**Town of Kittery
 Planning Board Meeting
 February 23, 2023**

ITEM 1 – 22 Shapleigh Road– Site Plan - Preliminary Plan Review

**RE: Town of Kittery, Planning Board Services
Fair Tide, Inc. Development
Tax Map 15, Lot 64
CMA #591.152**

UTILITY & EROSION CONTROL PLAN

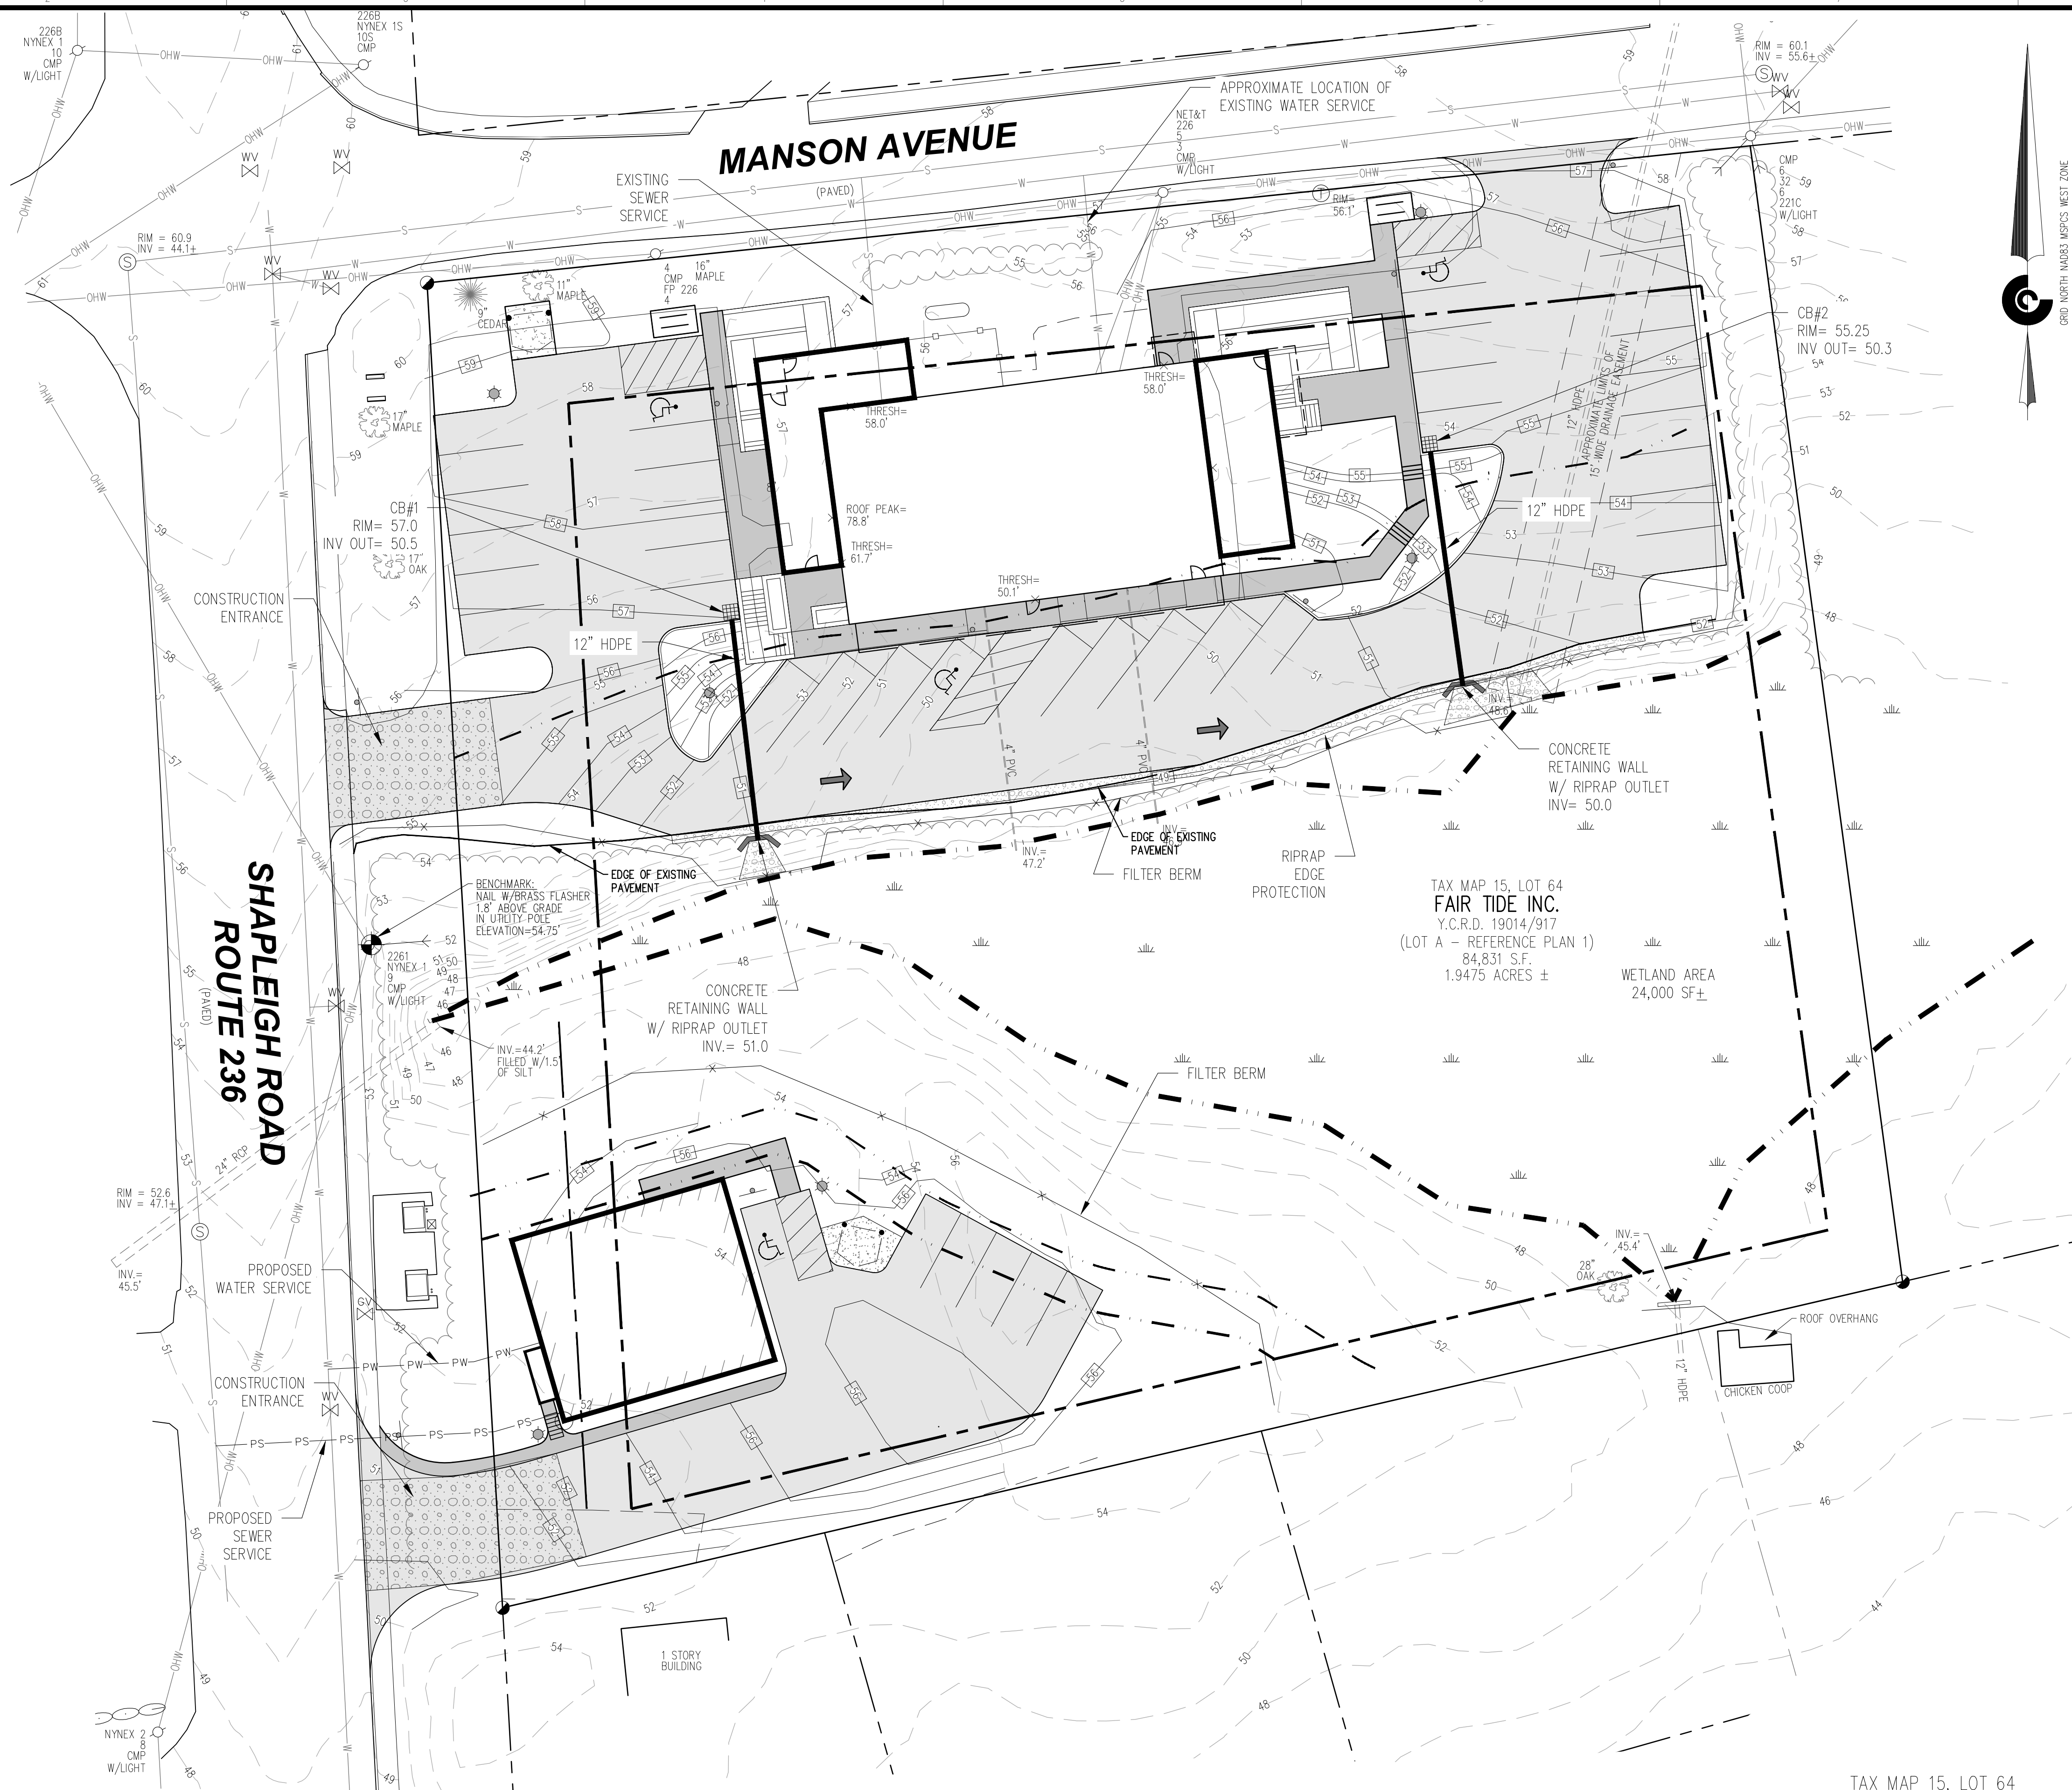
1. The plans should contain a legend.
2. All existing and proposed utilities and structures should be labeled with size, material, inverts, etc.
3. The existing water main on Shapleigh Rd is shown terminating at a gate valve by the concrete pad on Sheet EC but extending south on Shapleigh Rd on this sheet. Is a water main extension proposed? Please clarify.

4. The existing sewer main on Shapleigh Rd is shown terminating at a manhole with a rim elevation of 52.6'. Is a sewer main extension proposed? Please clarify.

5. The 24" RCP drainage pipe that crosses Shapleigh Rd and outlets onto the property is indicated “filled with 1.5' of silt”. Is there a plan to clean this pipe? What effect does this have on drainage?

6. It appears that the Manson Avenue and Shapleigh Rd accesses are both entrances and exits, but the pavement marking arrows show one way traffic behind the northern building from west to east. We note that the aisle width behind the building is not sufficient for two-way traffic. Please provide details for signs and show their locations on the plans.

7. Locations of handicap accessible and compact car parking signs should be shown on the plan.
8. The “area to be filled” to the north of the existing building should be graded to show finished grades. Where does the water go that used to pond or infiltrate here?

EC

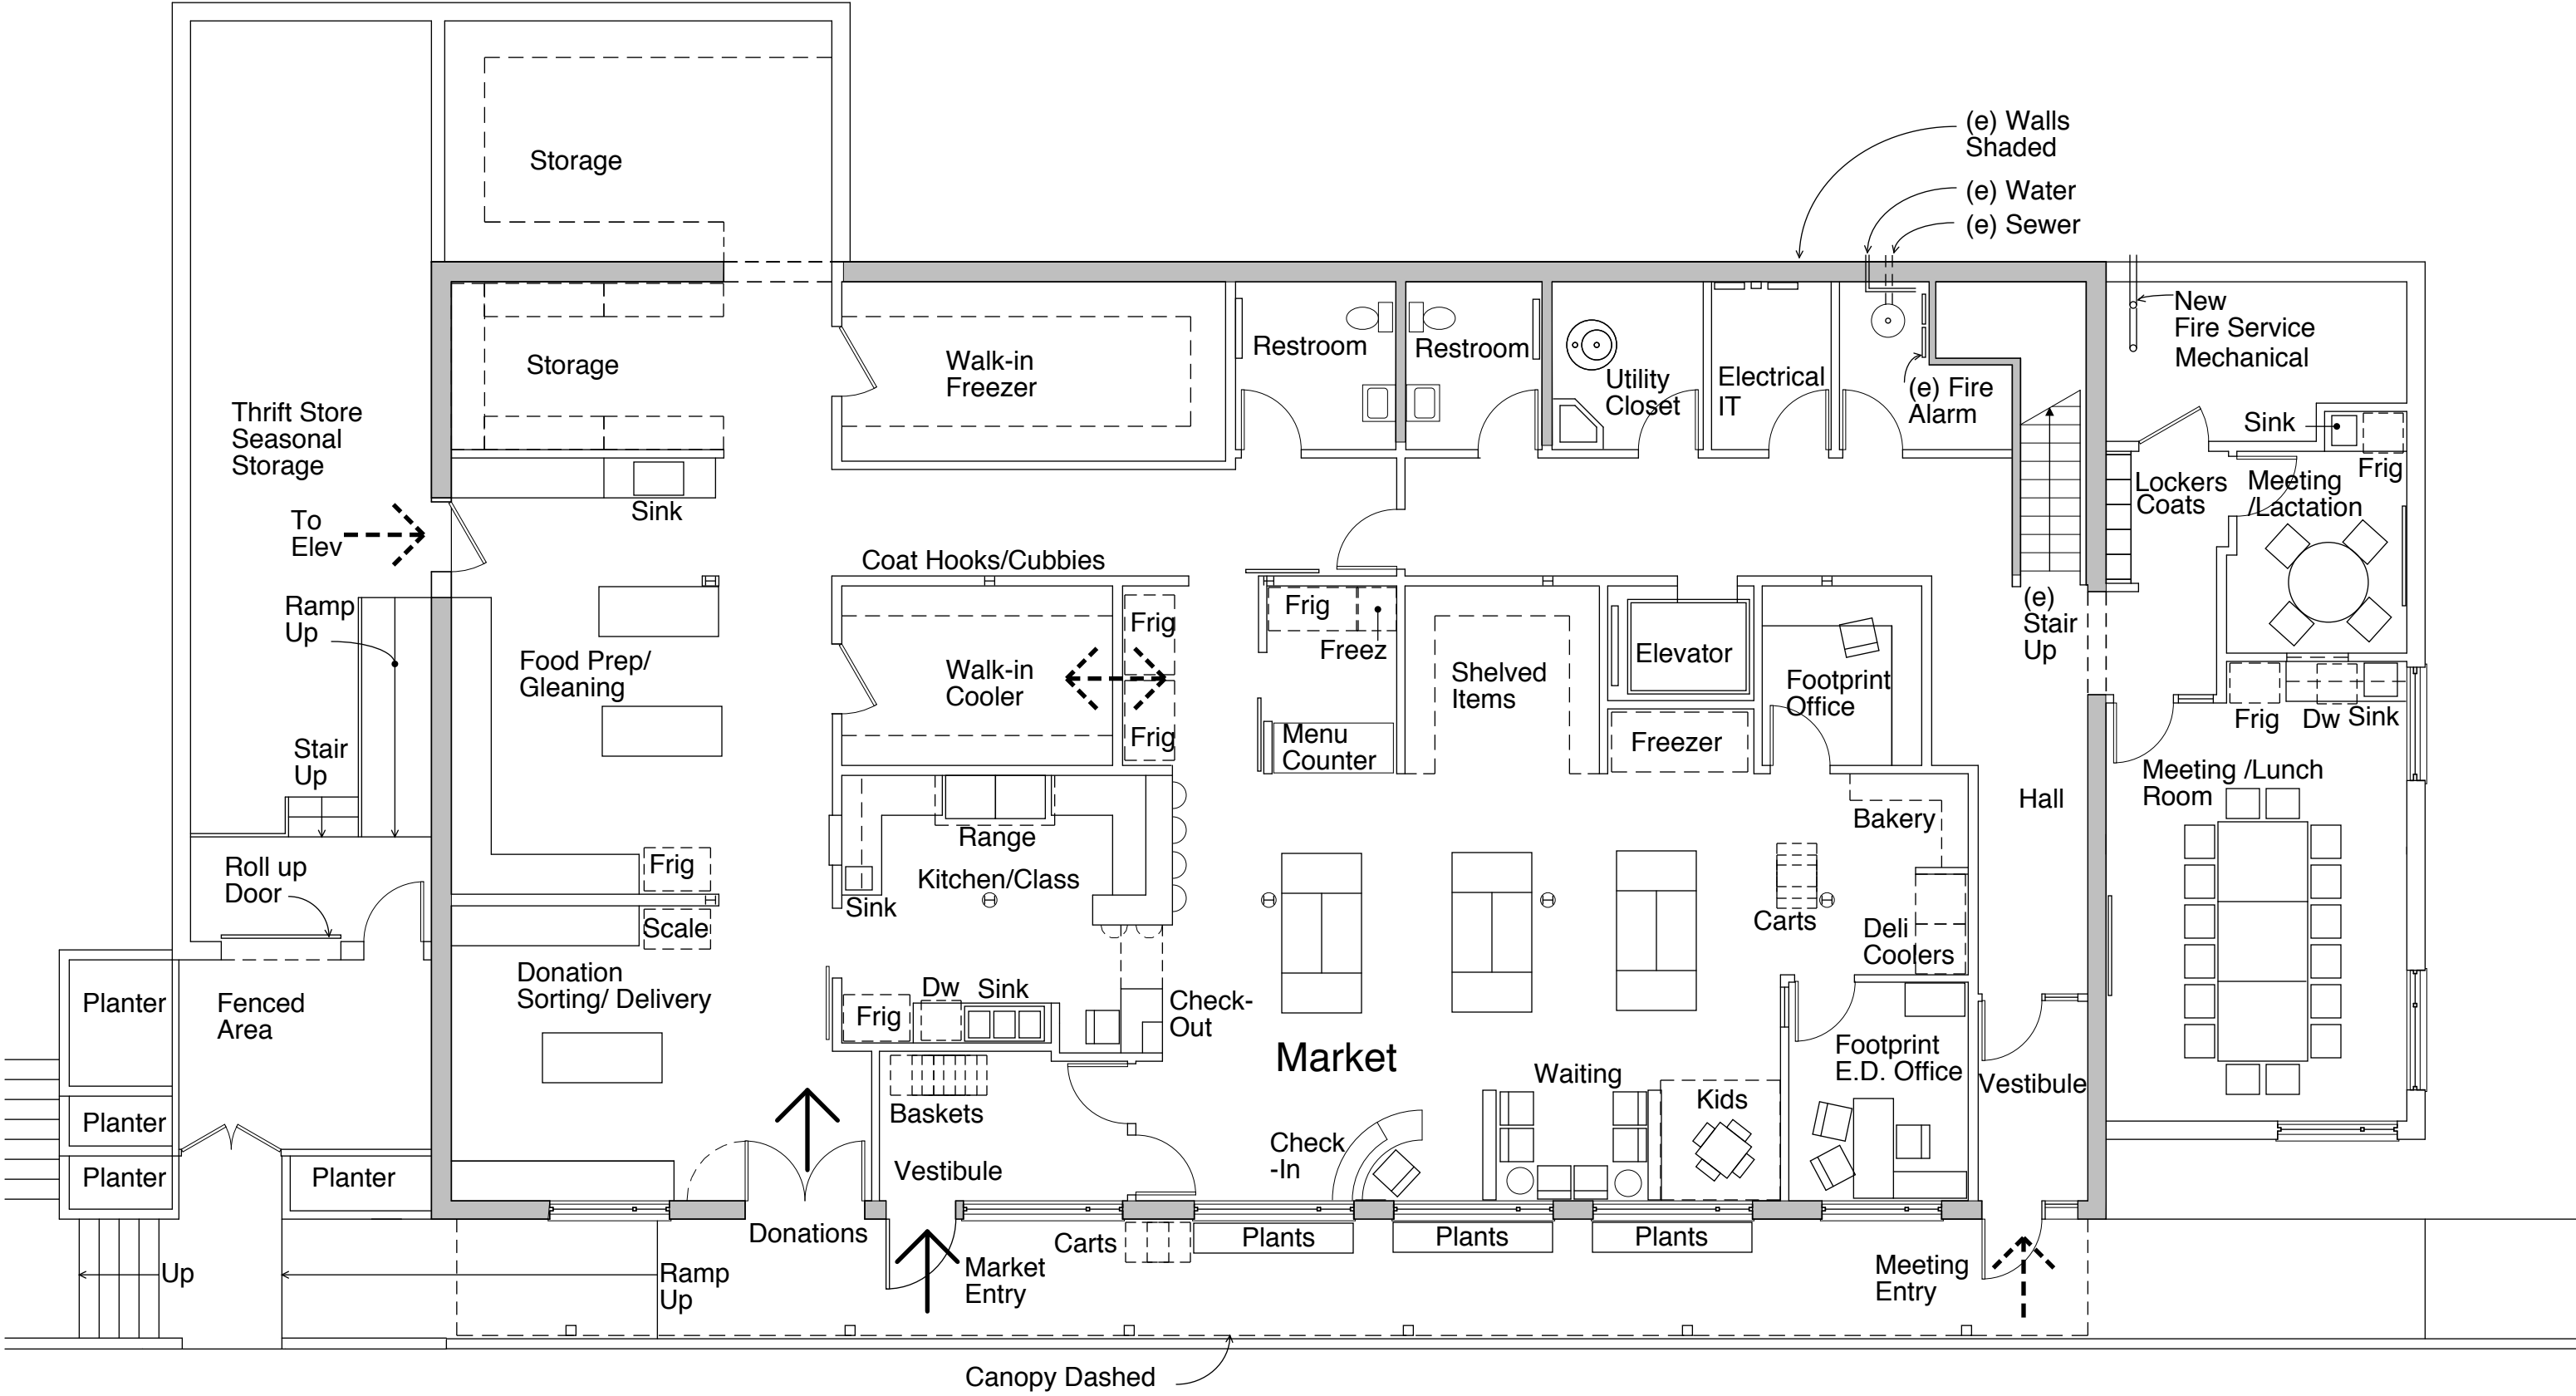
Existing Conditions Plan- EC:

1. The plan should contain notes.
2. The plan should contain a legend.
3. The Total Impervious Coverage adds up to 24,480 sf not 28,688 sf.
4. The existing utility sizes, materials and inverts should be labelled.
5. The existing sewer and water services and pipe materials should be labelled.
6. The existing water main on Shapleigh Rd is shown terminating at a gate valve by the concrete pad. Is this correct? Please clarify.
7. There is a gate valve south west of the concrete pad on Shapleigh Rd that doesn't connect to anything. Please clarify.
8. The existing sewer main on Shapleigh Rd is shown terminating at a manhole with a rim elevation of 52.6'. Is this correct? Please clarify.
